Tumalo Irrigation District

From: WILLIAMS Becky S * WRD <Becky.S.Williams@oregon.gov>
Sent: Thursday, June 4, 2020 8:08 AM
To: Lauren Reese <lauren@integratedwatersolutions.net>; 'Ken Rieck' <ken@tumalo.org>; 'Chris Schull' <chris@tumalo.org>
Cc: WRD_DL_waterprojects <WRD_DL_waterprojects@oregon.gov>
Subject: Deschutes Basin Flow Restoration – Group 3: Application completeness

Deschutes Basin Flow Restoration – Group 3

Attachment 1 - Site Map

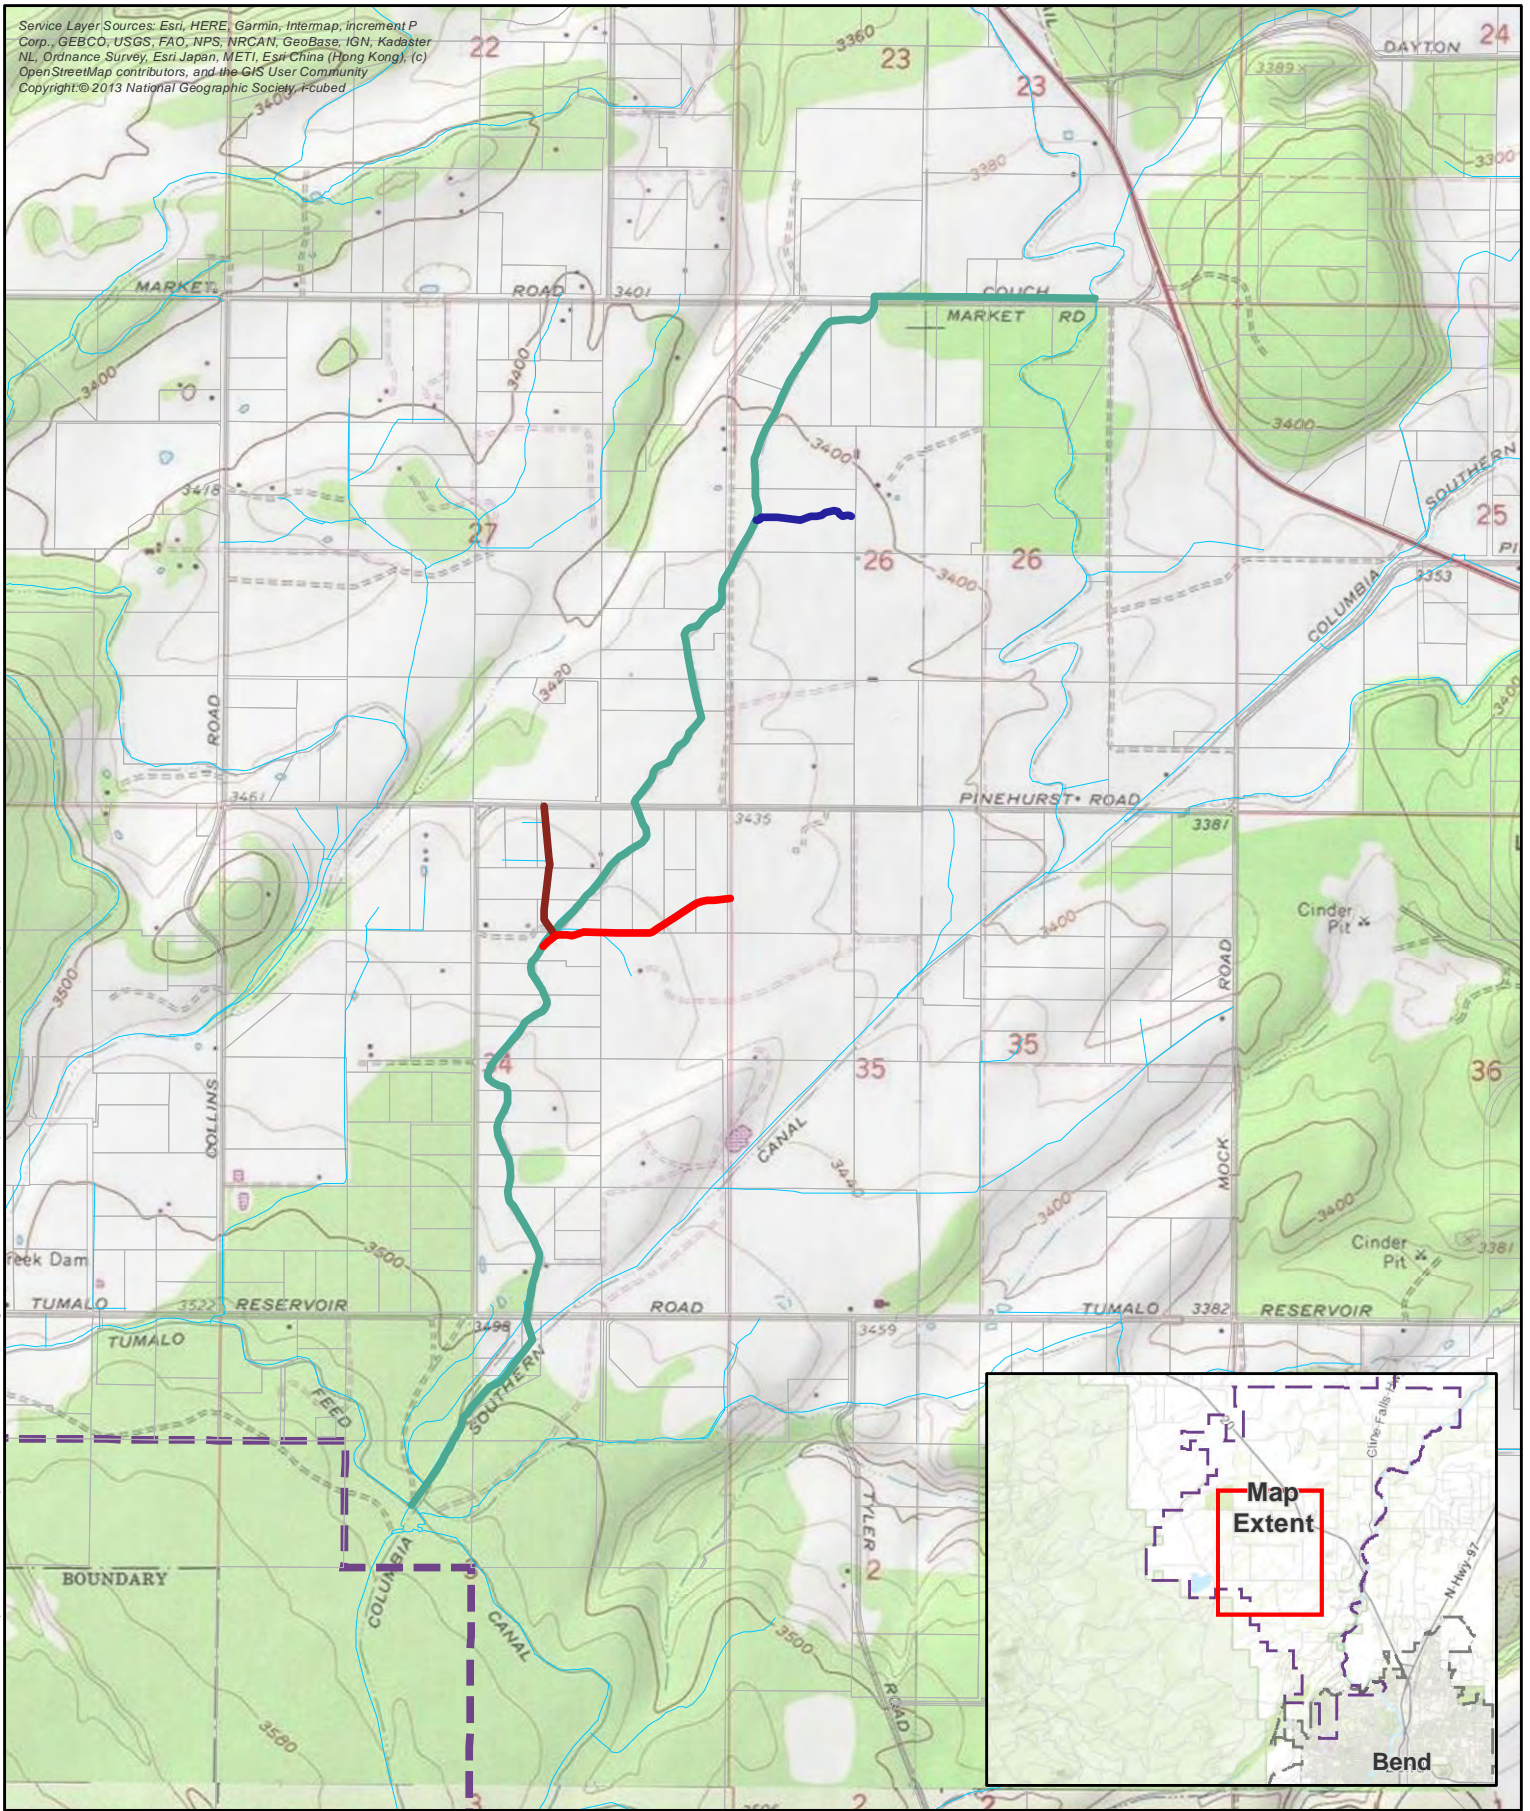
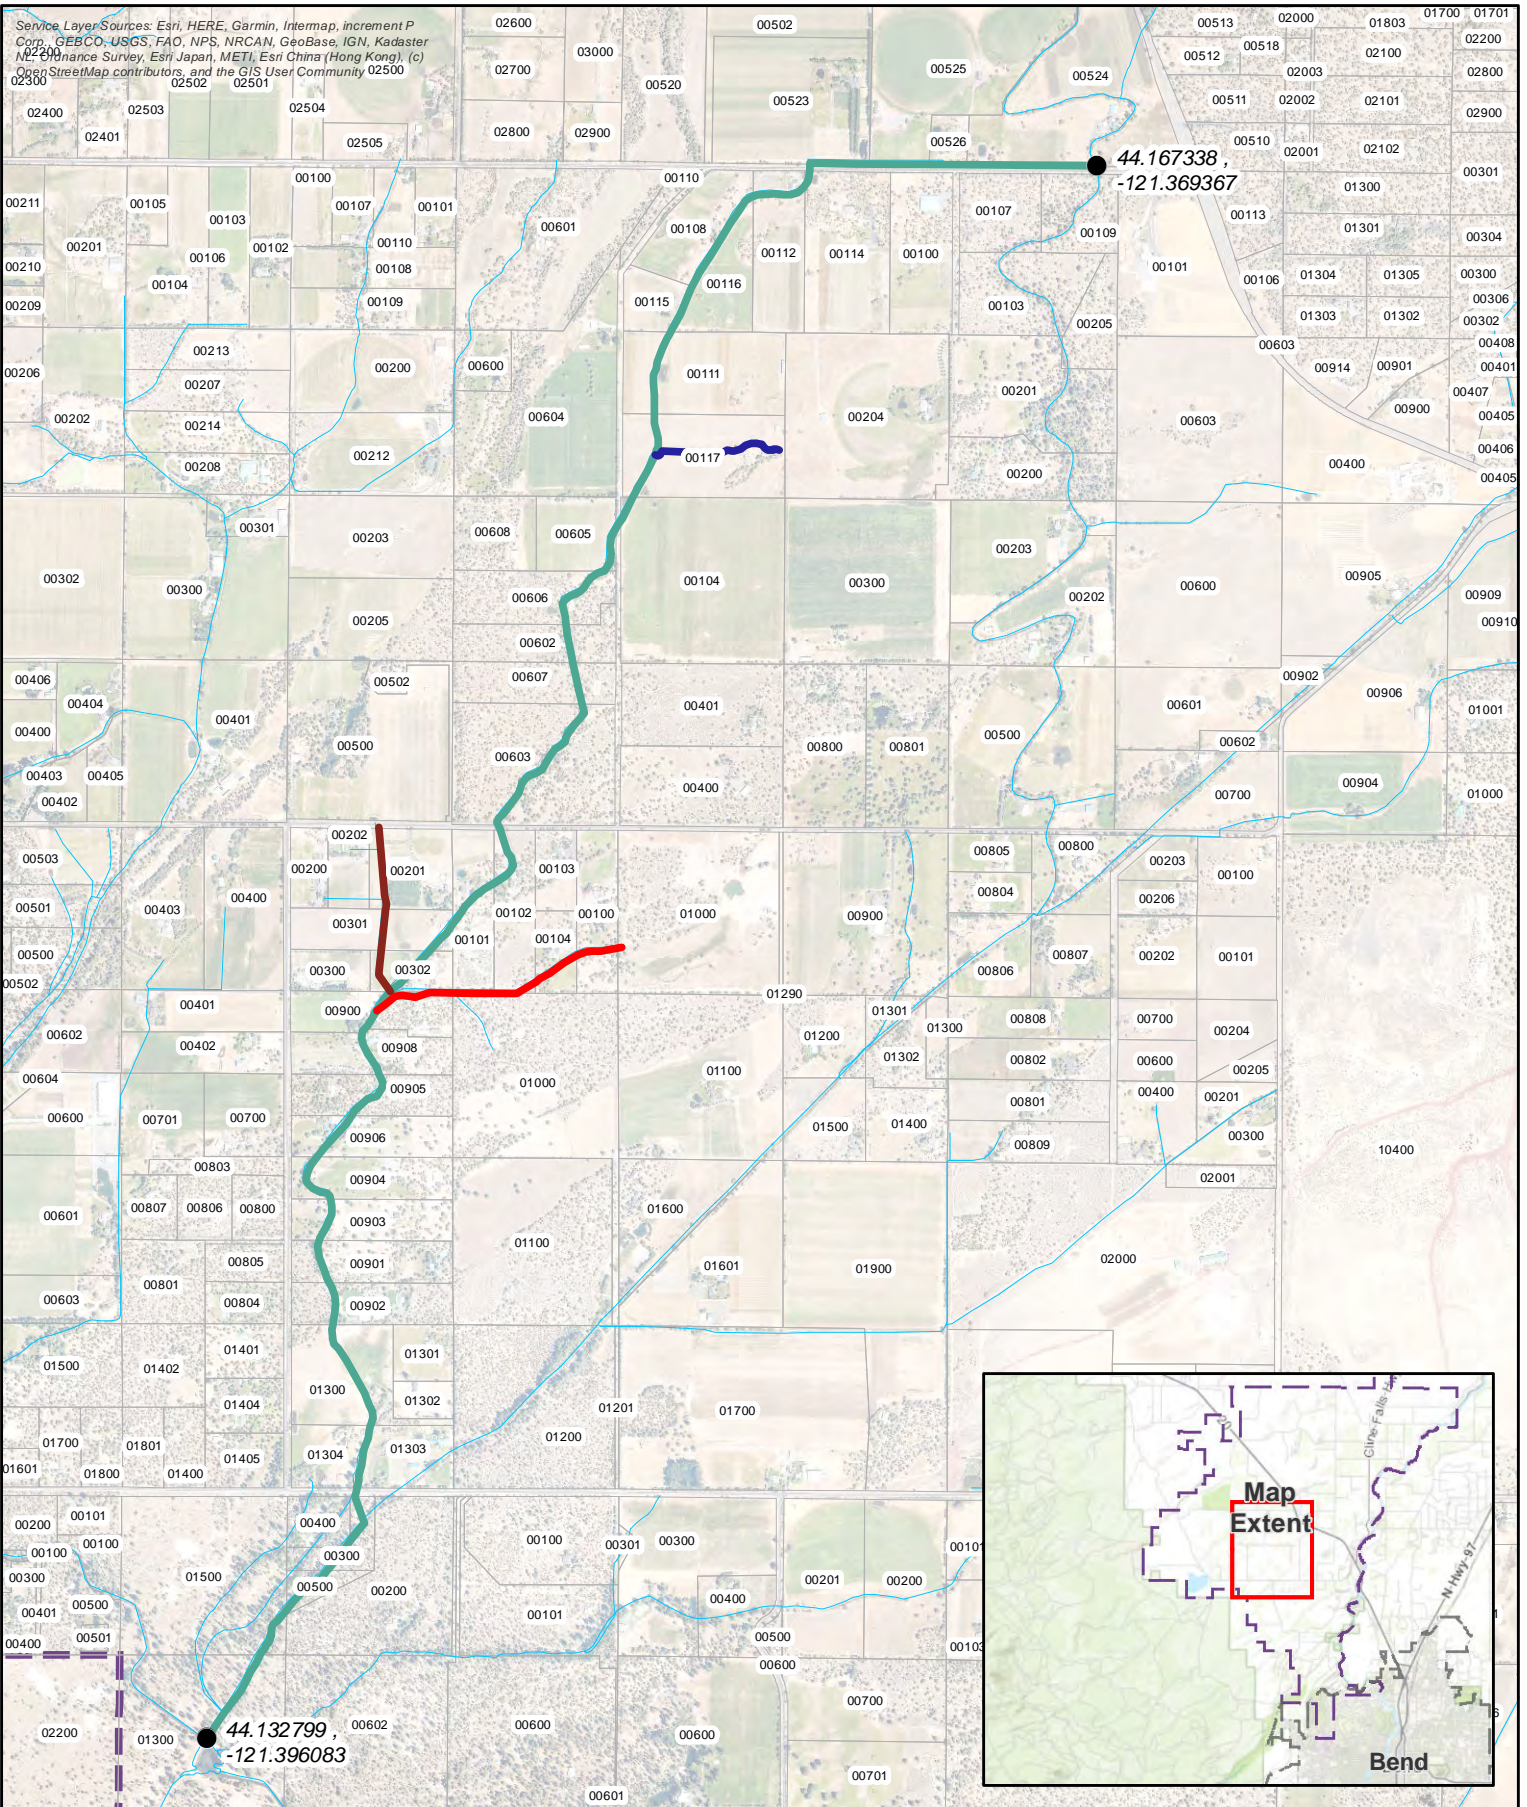
1. After working with a landowner, a portion of this pipeline was consolidated into one pipeline rather than three portions that were originally described in the grant application. We simplified the language to clarify that this project is to pipe the Allen lateral as well as its two sublaterals. The text in the application is revised, as well as Attachment 1 – Site Map for clarification.
